11/20/24 – 3rd Review Comment Letter

RE: **2-ZN-2024**
Artesa
G0949 (Key Code)

PRELIMINARY SEWER REPORT

PRELIMINARY Basis of Design Report

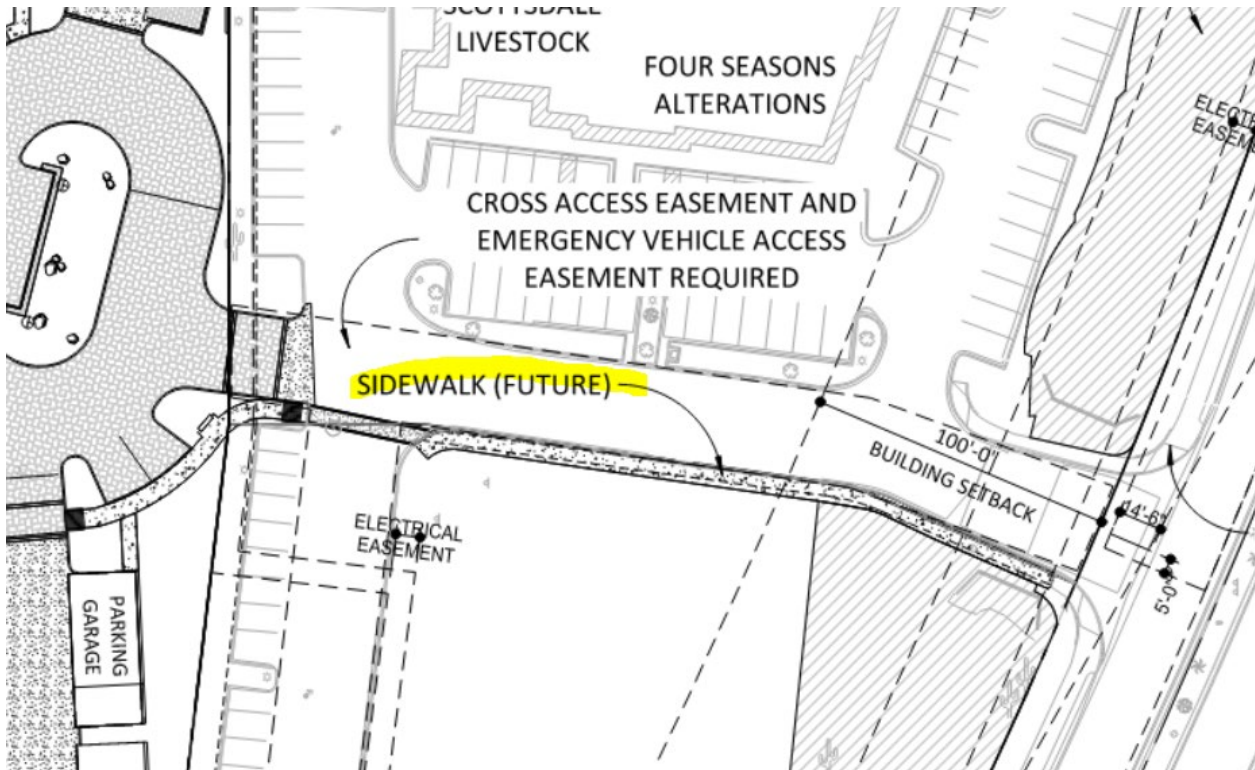
9. 1st- DSPM 2-1.309: REFUSE. Provide a refuse plan meeting all city refuse requirement given in DSPM 2-1.309.

2nd- Not addressed properly. Understood regarding 67 units but the 2 double enclosure placements to not comply with the requirement to provide a one direction pick-up route through project. As proposed, the truck would have to go in one way, exit to commercial area, turn themselves around, and go back in the way they came out to pick up the other enclosure. 1 double enclosure housing a 4 cubic yard vertical compactor and a refuse container could suffice for this development, else relocate one of the enclosures so it can be picked up from the same direction as the other.

3rd- Not addressed. Refuse plan does not demonstrate compliance for a 40' truck's 45' truck turning radius into and out of the proposed refuse enclosures, nor that the refuse truck does not need to back track to serve the multiple containers proposed.

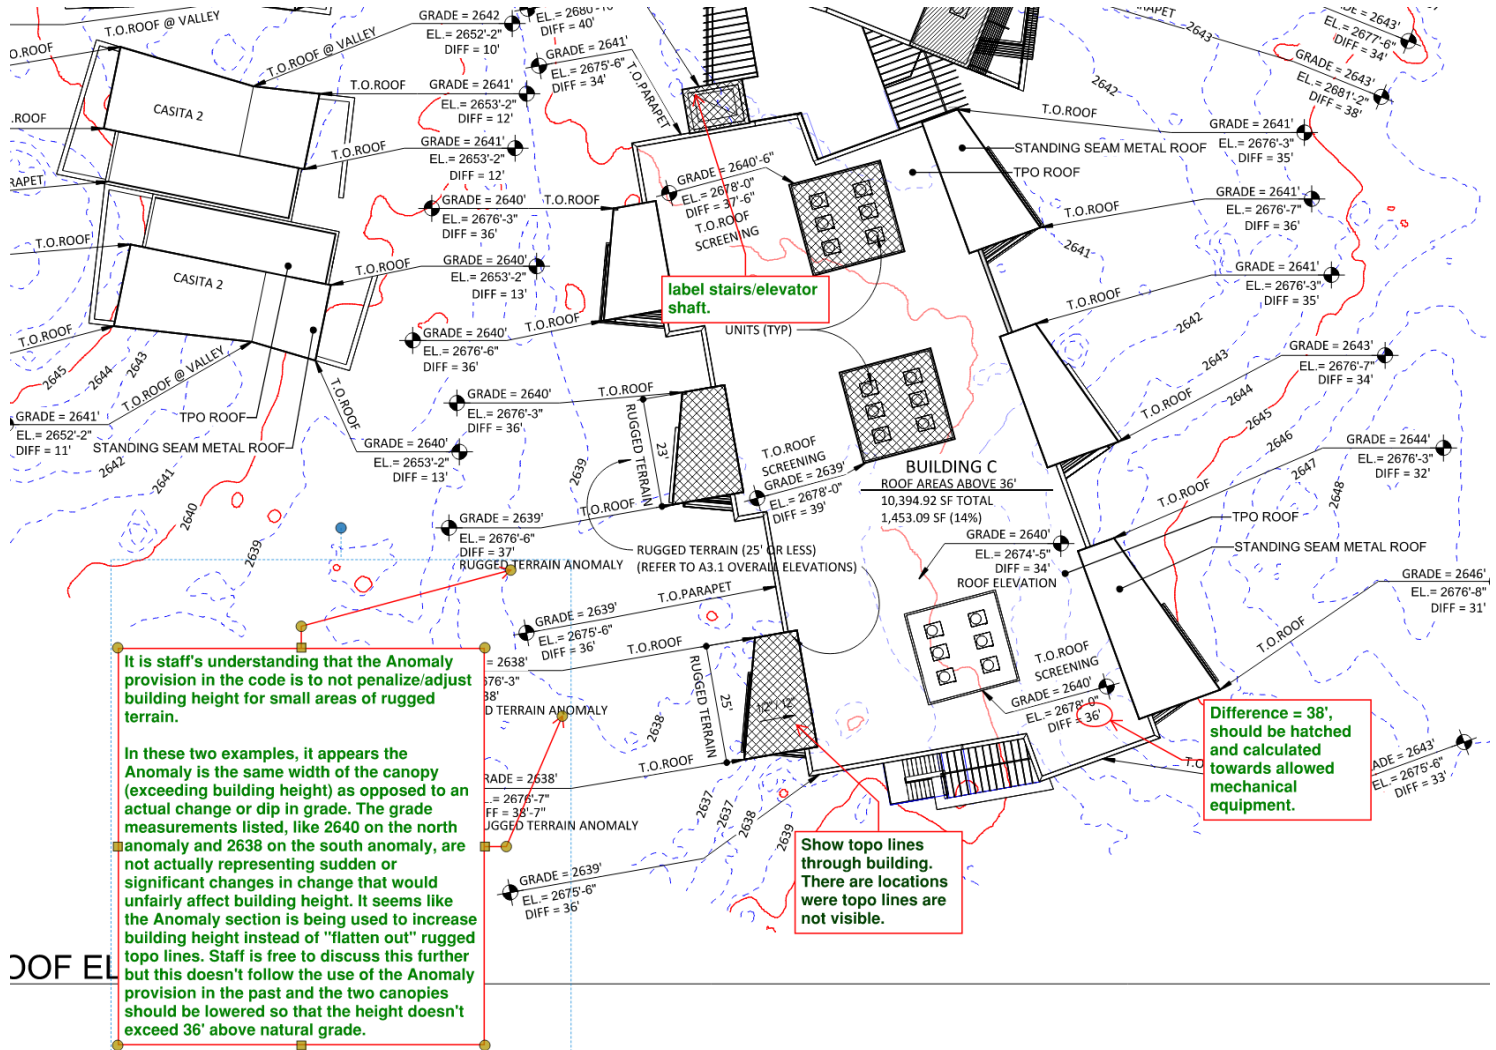
16. Development Agreement and subdivision plan still needs to be resubmitted to address staff comments. Case 2-DA-2024.
17. The topography analysis was provided per requested via previous comments to determine the NAOS required for the entire development. However some things are still unclear. 1 – How was it determined that 6.10 acres of NAOS was required for the whole site? 2-The topography plan is only showing the requirement for residential lot, and that numbers differs from the NAOS plan, please explain.

SLOPE CATEGORY	NAOS FACTOR	TOTAL SLOPE AREA (S.F.)	NAOS REQUIRED (S.F.)
0.0%-5.0%	25%	112,731	28,183
5.0%-10.0%	35%	60,066	15,017
10.0% <	45%	201,623	90,730
TOTAL		374,420	133,930

PARCEL	% SITE	SITE AREA	AREA REQ	NAOS PROVIDED
APN 216-81-379	28%	5.7 AC	1.70 AC	1.20 AC (52,421 SF)
APN 216-81-380	8%	1.61 AC	0.49 AC	0.66 AC (28,753 SF)
APN 216-81-381	43%	8.59 AC	2.62 AC	2.95 AC (128,616 SF)
APN 216-81-382	15%	2.92 AC	0.92 AC	0.98 AC (42,765 SF)
APN 216-81-383	6%	1.11 AC	0.37 AC	0.32 AC (14,258 SF)
TOTAL NAOS		19.94 AC	6.10 AC	6.12 AC (266,813 SF)

C4.30

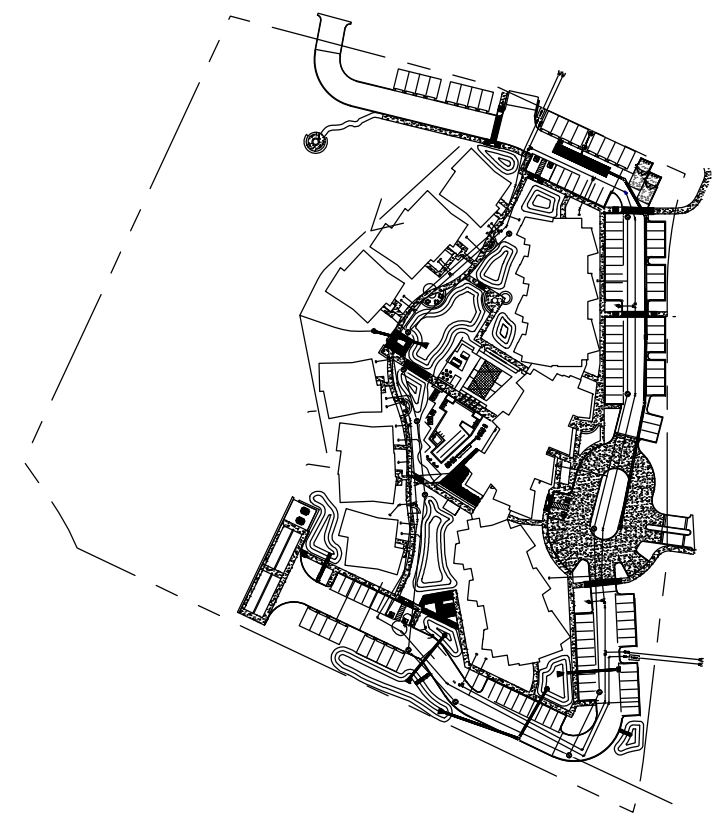
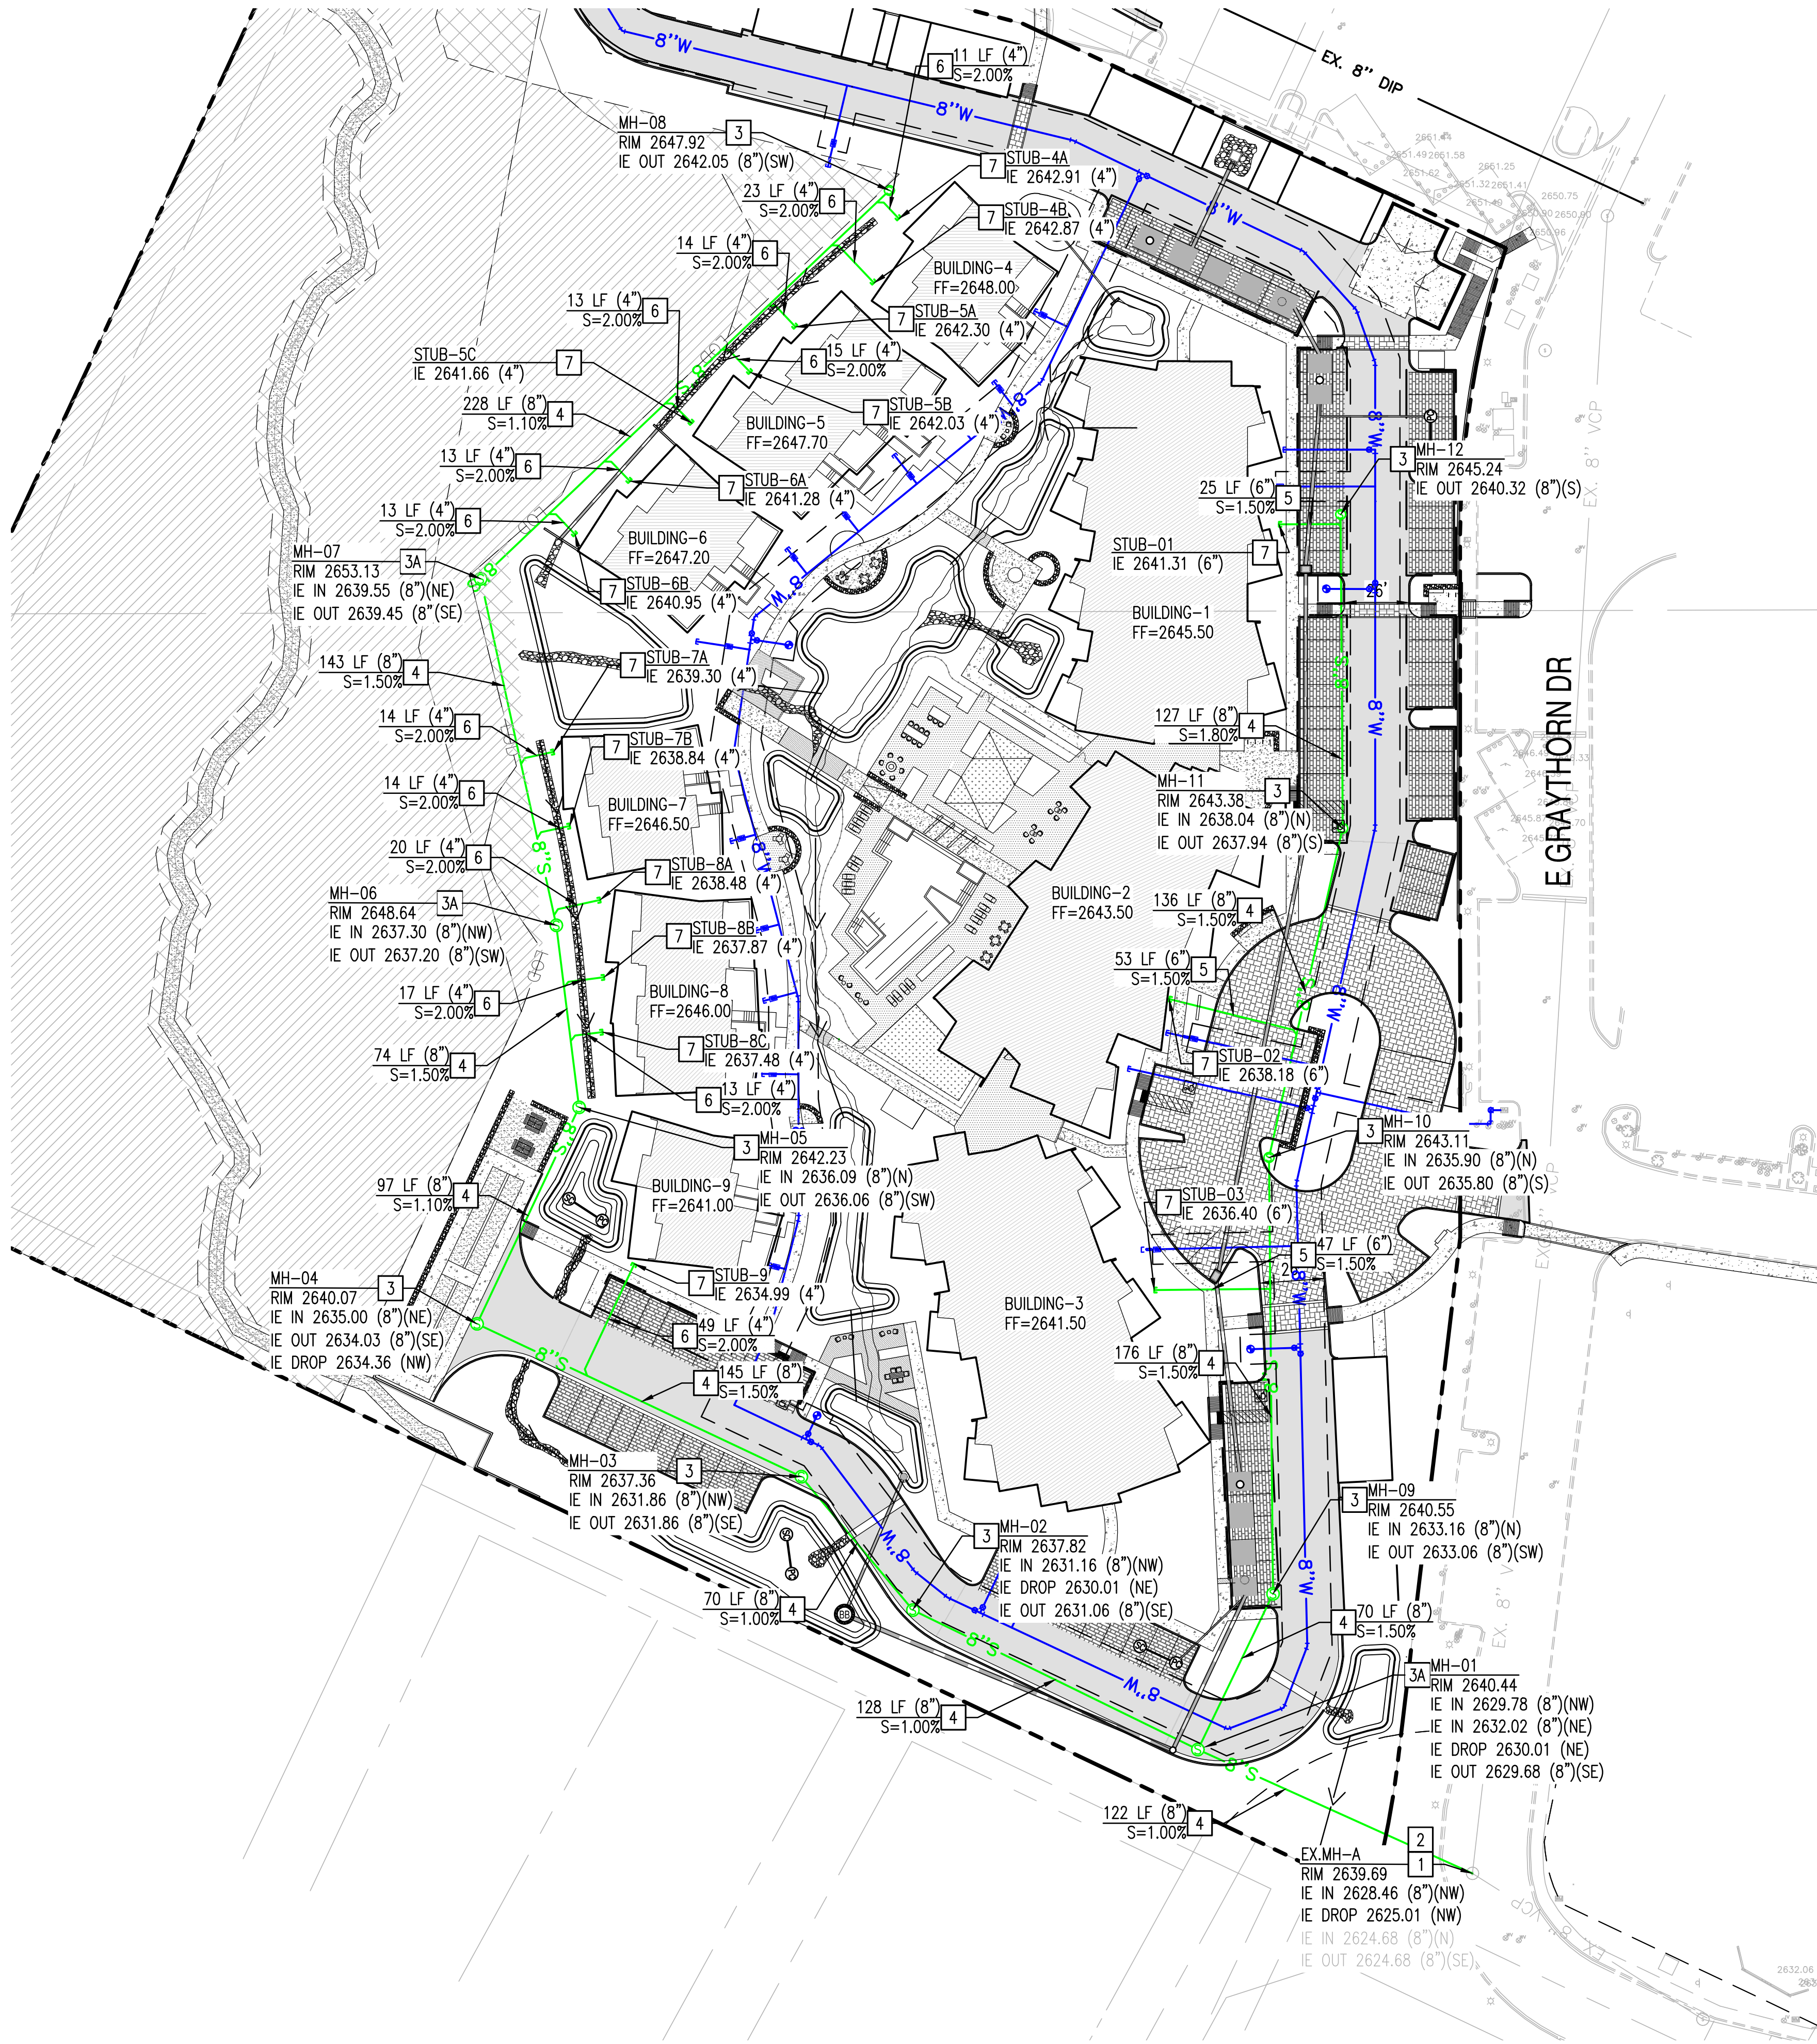
750' downstream, there is additional wastewater inflow into 8" pipe @ Alma School Rd.
